Design and Historic Review Commission Agenda

Wednesday, May 12, 2021, 4:00 p.m.

STAFF REPORT
TO THE DESIGN AND HISTORIC REVIEW COMMISSION
CASE #: DHRC-34825-2021
DEPARTMENT OF COMMUNITY DEVELOPMENT
COMMUNITY PLANNING DIVISION
CASE PLANNER: BOB BLEVINS

Re: Drake Building Structural Review
29 – 39 West 2nd Street
Yuma AZ

Photo: P11

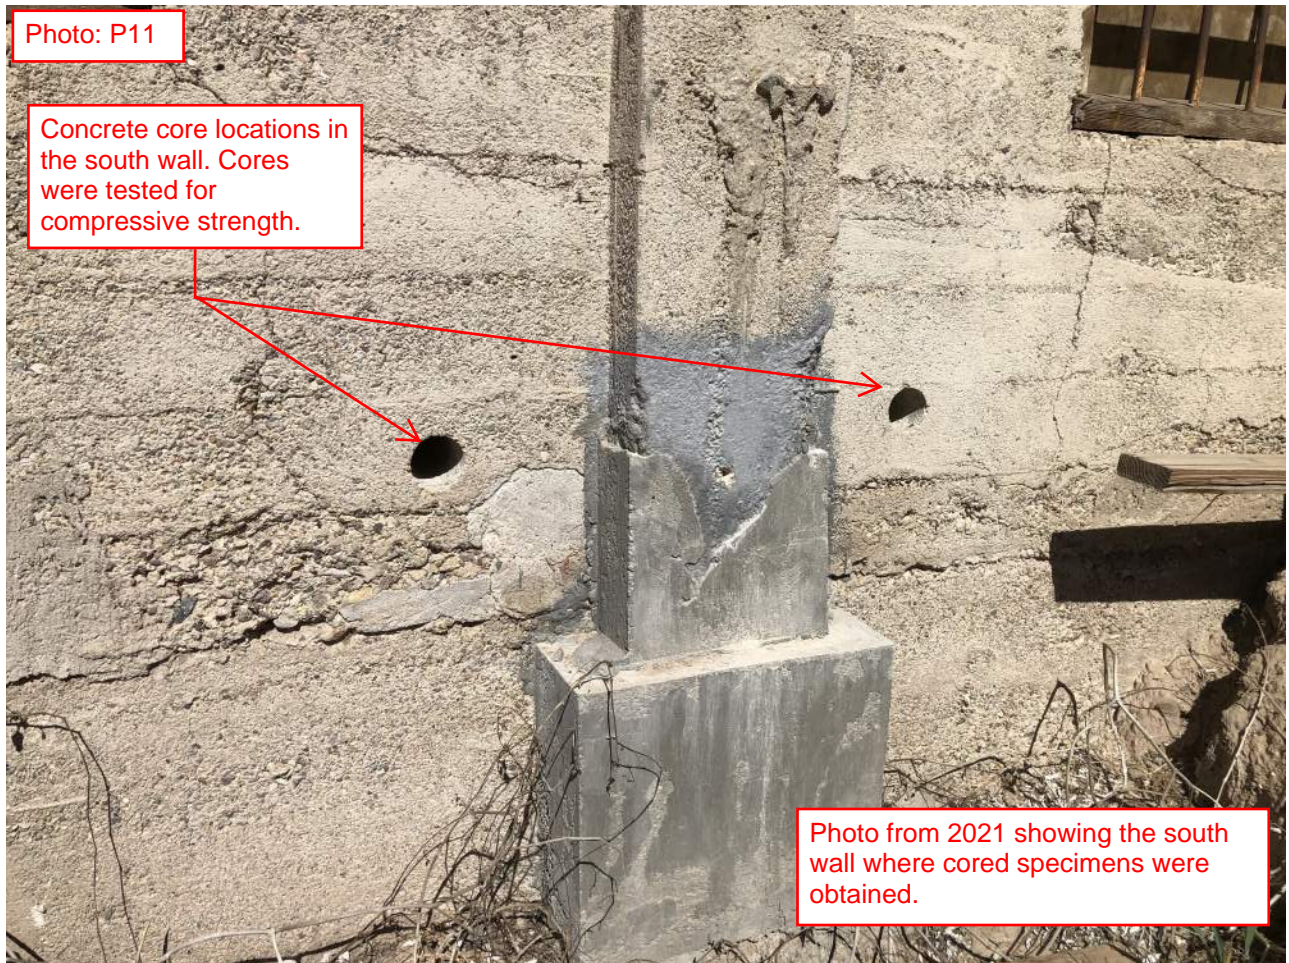
Concrete core locations in the south wall. Cores were tested for compressive strength.

Photo from 2021 showing the south wall where cored specimens were obtained.

Photo: P12

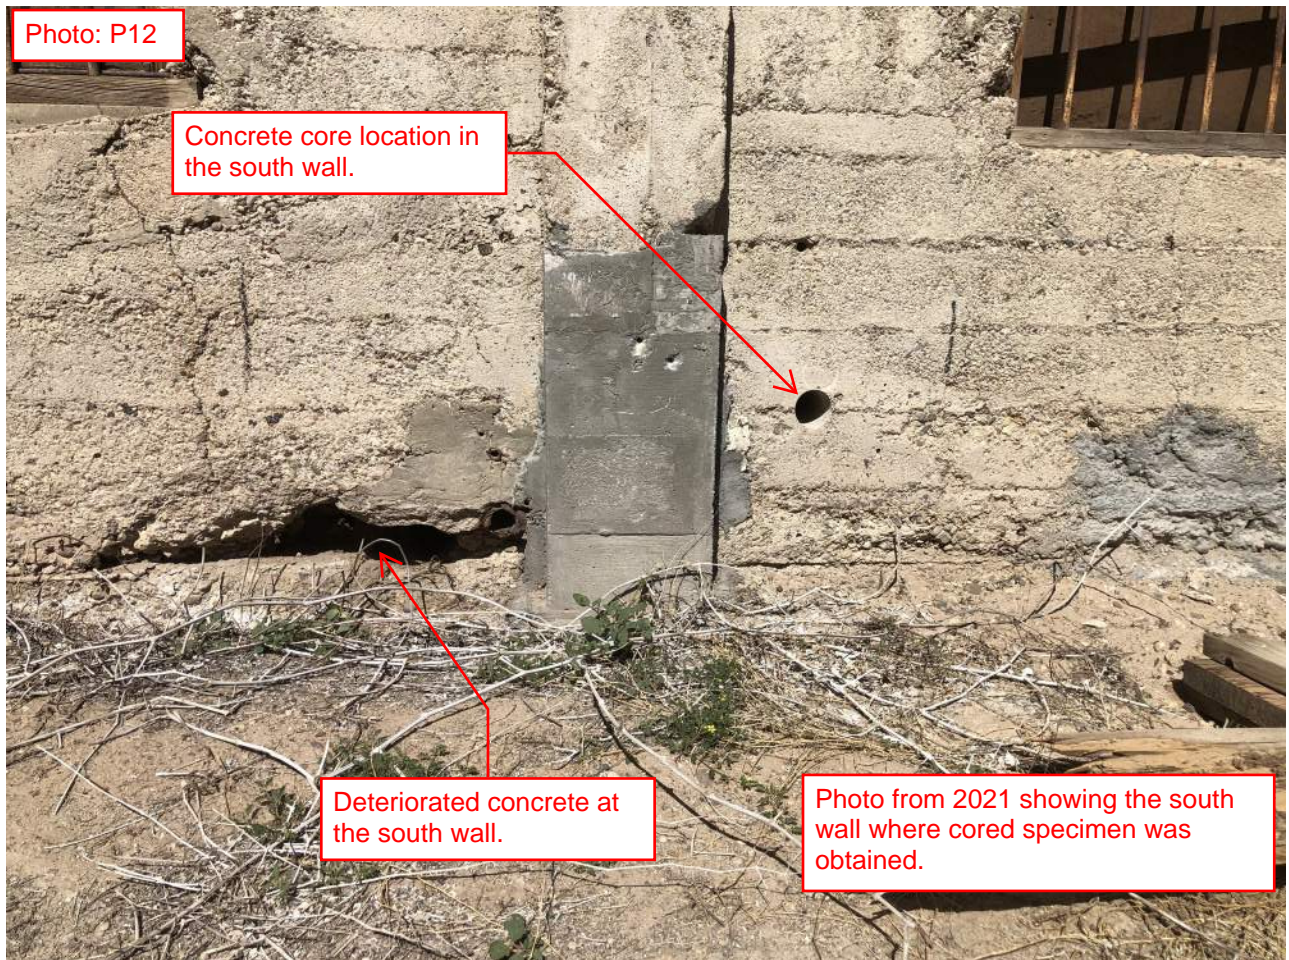
Concrete core location in the south wall.

Deteriorated concrete at the south wall.

Photo from 2021 showing the south wall where cored specimen was obtained.

Photo: P13

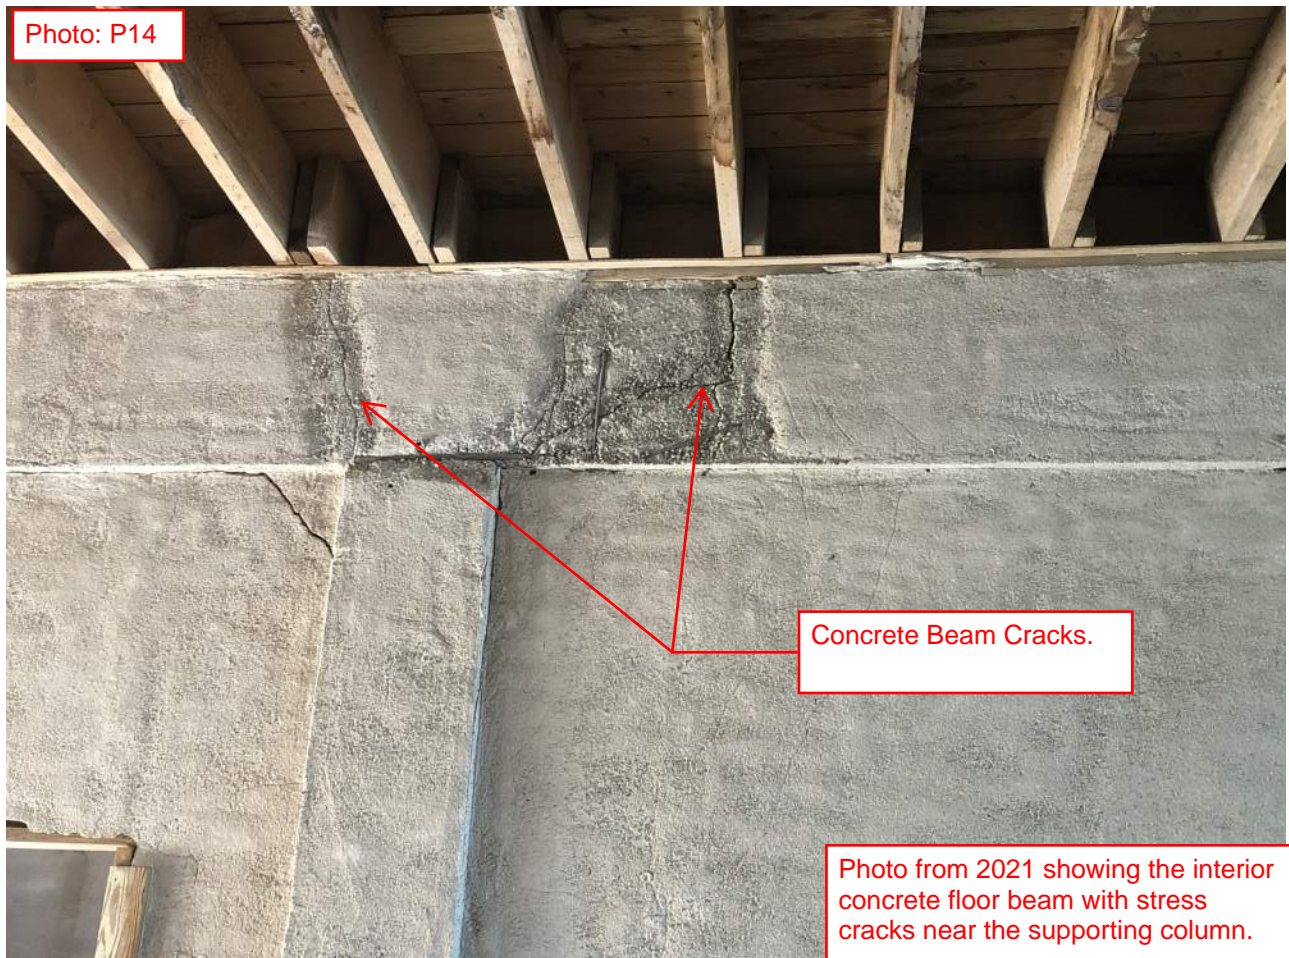
Inadequately consolidated concrete at the south wall.

Photo from 2021 showing the south concrete wall over a door opening.

Photo: P14

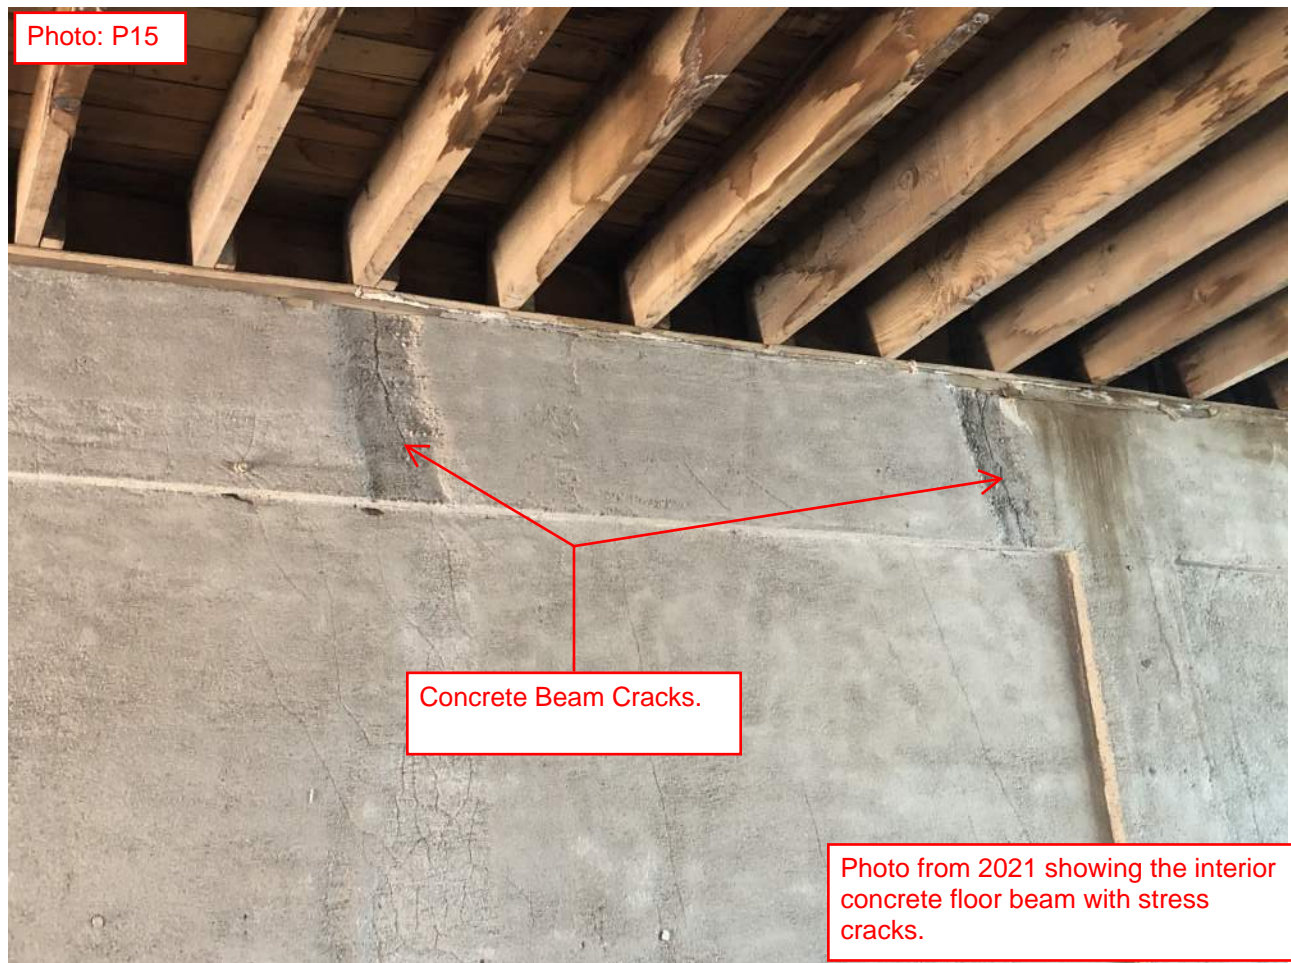
Concrete Beam Cracks.

Photo from 2021 showing the interior concrete floor beam with stress cracks near the supporting column.
